NEW DESIGN OF CONTROL PANEL

DESCRIPTION:

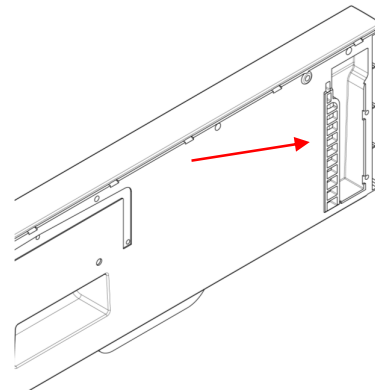
Control panels 1561440023 and 140003084021 will not be available. It can be replaced by part 140003084039, but new panel is not dedicated for IKEA "RESONLIG" set. Due to this it is necessary to remove mentioned set and replace some additional components.

Old control panel

New control panel

Depending on the method of installation following parts should be used:

1. Dishwasher was not installed using any optional kits:

Description	Spare part code	Quantity
Control panel	140003084039	1

2. Dishwasher was installed with IKEA "RESONLIG" set:

Description	Spare part code	Quantity
Control panel	140003084039	1
Outer door	1560285866	1
Inner door	140025959028	1
Hinge kit	4055350963	1
Mounting kit	1561714005	1
Template	140021487032	1
Hinge rod	1172954040	1
Distance piece	140025501010	1
Manual	1561703024	1
Door gasket	1527401002	1
